Re: Inquiry into the draft Disability (Access to Premises – Buildings) Standards 2009

**Submission to House of Representatives
Standing Committee on Legal and Constitutional Affairs
Inquiry into the draft Disability (Access to Premises - Buildings) Standards 2009**

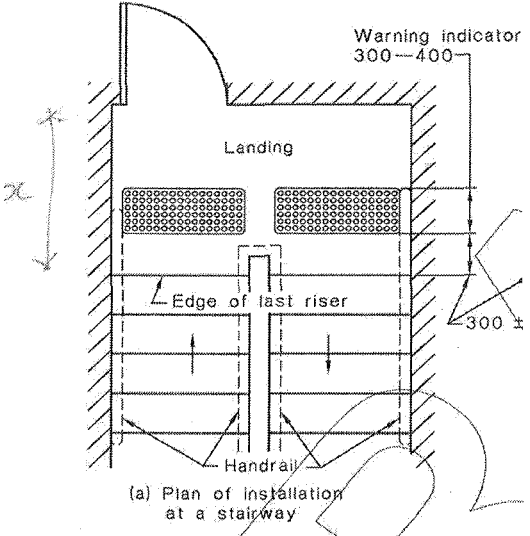
Document/Part	Clause/Table/Figure	Comments & Proposed Amendments
16 Sanitary Facilities	Clause 16.5.2 (b) & (c) Figure 49	<p>The gradients required in 16.5.2 (c) are extremely difficult, if not impossible, to achieve in practice where the recess is 1100 x 1600 and the floor waste is located as per Fig. 49</p> <p><u>Proposed amendment</u></p> <p>Amend & Change text and diagram</p> <p><i>(b) The waste outlet for the showerwith Figure 49."</i></p> <p><i>(c) The slope of the floor of the shower recess shall have a gradient between 1 in 50 and 1 in 80 and the floor waste shall be located at 550±25 from 3 sides of the shower recess (see Figure 39 and Figure 49)."</i></p> <p>Consider</p> <p>Provision of a continuous grated trench in the shower recess in lieu of the floor waste, which will minimise conflicting slopes and make it easier to achieve the required floor gradients. This has been shown to work and would be a good alternative.</p>

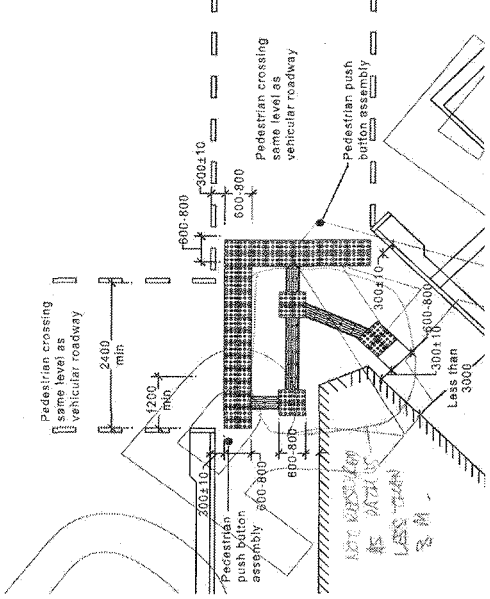
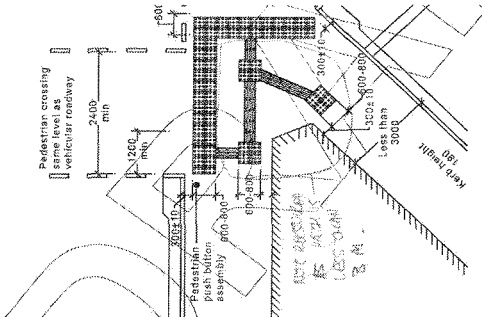
Document/Part	Clause/Table/Figure	Comments & Proposed Amendments
EXHIBIT 10		
Section 2	Clause 2.2.2(g) Figure 1	The application of this Clause will result in a TGSi area of less than $300 \pm 10\text{mm}$. <u>Proposed amendment</u> Change <i>“(g) where discrete warning TGSIs are used, the arrangement shall be as shown in Figure 1 with a minimum of 7 discrete warning TGSIs.”</i>
Section 2	Clause 2.2.2(b) Clause 2.2.2(g)	The requirements of these Clauses cannot be achieved for a curved line illustrated in Figure 5.
Section 2	Figure 2 (a)	This layout is applicable to the main floor of most stairs. It is understood that the provision of 300mm deep warning TGSIs is based on the expectation that a person who has to open the door to get to the stairs would not be walking at a rapid pace and thus would be able to detect the shallower warning TGSIs. However, this would only apply where the distance from edge of last riser to doorway (marked as "X" in diagram below) is short. This provision could be misleading if the distance allows the person to walk fast.  <p>(a) Plan of installation at a stairway</p> <u>Proposed amendment</u> Add Define the distance from edge of last riser to doorway (marked as "X") for the application of 300mm-deep TGSIs, beyond which 600mm-deep TGSIs must be provided.

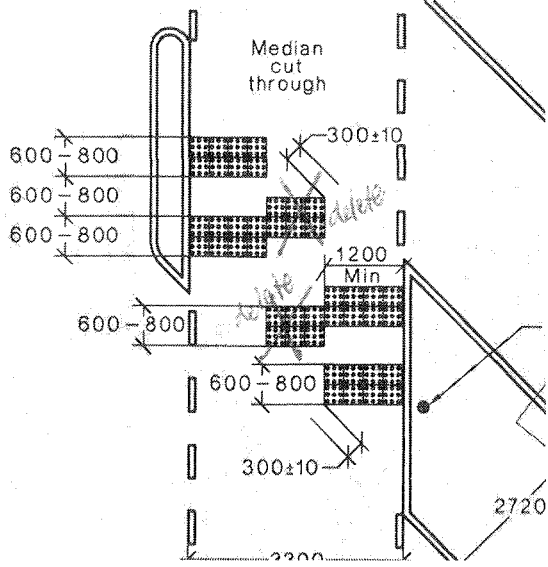
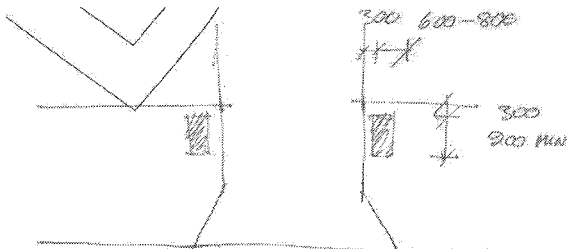
Section 2	Figure 9	<p>The illustration shows 7 bars within a 300mm-wide (150 + 150) directional TGSi. This is not consistent with the design/spacing shown in Figure 8 and in conflict with the note "300 – 400 wide".</p> <p>The illustration should either be drawn accurately or be shown diagrammatically only and "300 – 400 wide" consistently shown.</p>
Section 2	Figure 11	<p>Directional indicators at bus stops should start at 300±10mm from the building line to be consistent with the provision at mid-block crossing.</p>
